Application No. 10/579,444
Amendment dated June 16, 2008
Reply to Office Action of March 27, 2008

Amendments to the Drawings:

REMARKS/ARGUMENTS

Appl. No. 10/579,444
Amdt. Dated June 20, 2008
Reply to Office Action of March 27, 2008

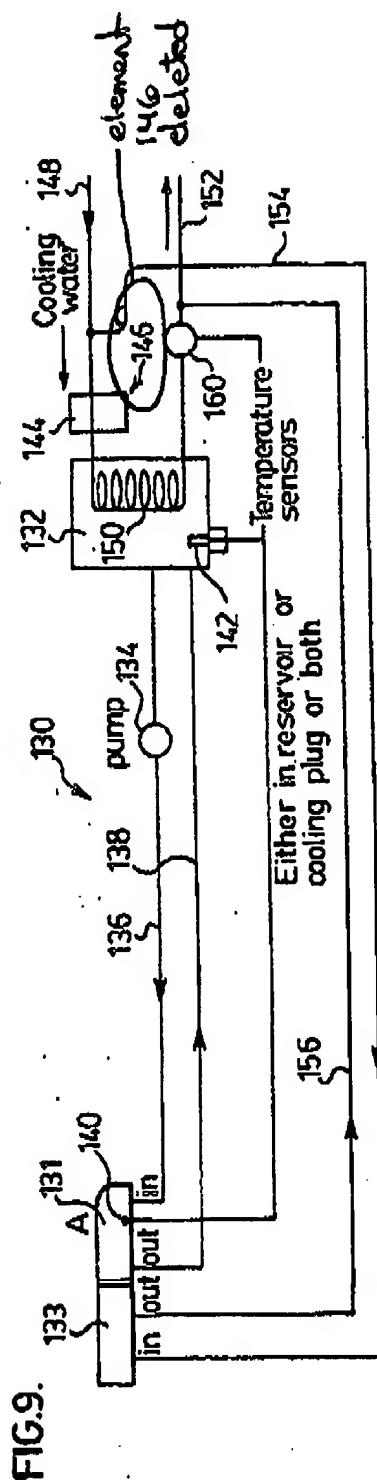
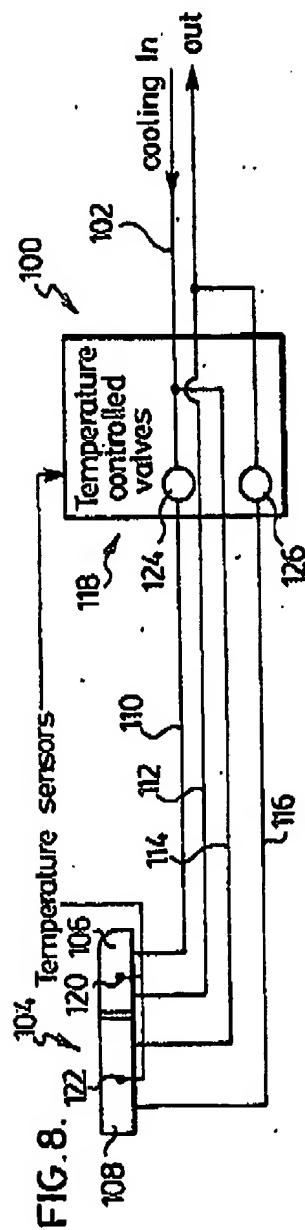
The attached sheet of drawings includes changes to Figure 9. This sheet, which includes Figures 8-11, replaces the original sheet including Figures 8-11. In Figure 9, element 146 has been deleted.

With respect to the drawings, reference character 146 has been deleted from Figure 9 and reference character 112 has been added to the description. The replacement paragraph at line 30 on page 15 has now been corrected. Claims 1, 2 and 4 were rejected under 35 U.S.C. 103(a) as being unpatentable over Lupke et al. US Patent 4,510,013 in view of Chan US Patent 4,789,327.
